SAFETY EVALUATION FOR NEDC-33239P, "GE14 FOR ESBWR NUCLEAR DESIGN REPORT," AND NEDE-33197P, "GAMMA THERMOMETER SYSTEM FOR LPRM CALIBRATION AND POWER SHAPE MONITORING," LICENSING TOPICAL REPORTS FOR REFERENCE IN THE ECONOMIC SIMPLIFIED BOILING-WATER REACTOR DESIGN CERTIFICATION APPLICATION

The staff of the U.S. Nuclear Regulatory Commission (NRC) reviewed the information contained in licensing topical reports (LTRs) NEDC-33239P, "GE14 for ESBWR Nuclear Design Report," and NEDE-33197P, "Gamma Thermometer System for LPRM Calibration and Axial Power Shape Monitoring," for application to the economic simplified boiling-water reactor (ESBWR). These LTRs describe core cycle analysis and online monitoring methodologies.

Figure A.2.1 Normalized GT response and power shape (control blade at 45.11 cm)

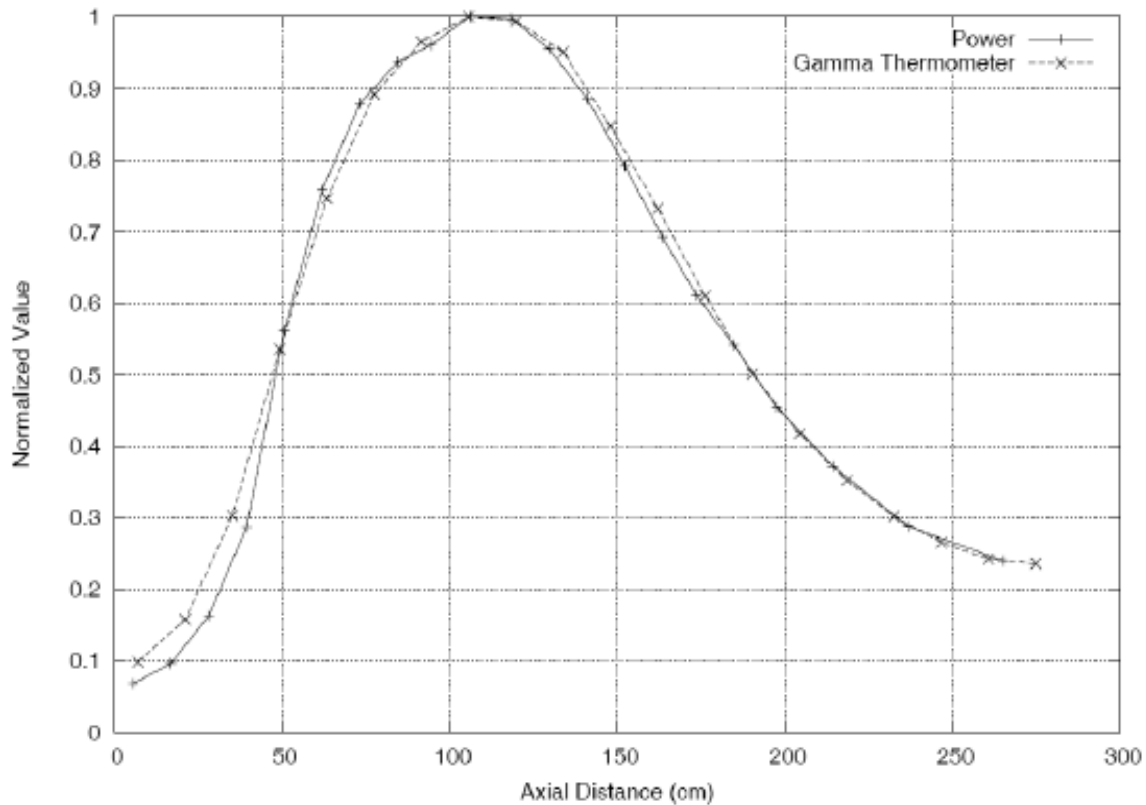
For the shallow insertion depth, the axial power shape is mid-peaked. The results show that the GT instrument reading and the nodal axial power shape are in very close agreement above the control blade. For the nodes below the control blade tip, there is an apparent bias in the GT reading. The staff, however, noted that the plots compare the axial fission power and the axial indications of GT heat deposition. Figure A.2.1 depicts the shallow insertion calculation results.

For partially controlled nodes, the J-factors are combined according to the local geometry correction methodology provided in the response to Request for Information 7.2-72 (for additional information regarding the staff's technical review, see Item B.54 in Appendix B to this safety evaluation). This methodology accounts for the potential for the fine motion control rod drive to position a control blade partially through a node near a GT sensor.

Overall, the staff's confirmatory calculations provide additional assurance that the applicant's characterization of the GT in-plant operation is consistent with the expected heating of the instrument. Similarly, the confirmatory calculations indicate that the J-factor approach considers the appropriate phenomena to account for the axial power variation introduced by the control blades. This is further confirmed by Limerick 2, Tokai 2, and K5 in-plant tests showing good agreement between the GT "measured" local power and the thermal traversing in-core probe "measured" local power distributions in the GT LTR. In this case, the staff uses the term "measured" to mean that these distributions are the reactor power distributions inferred from the instrument readings.
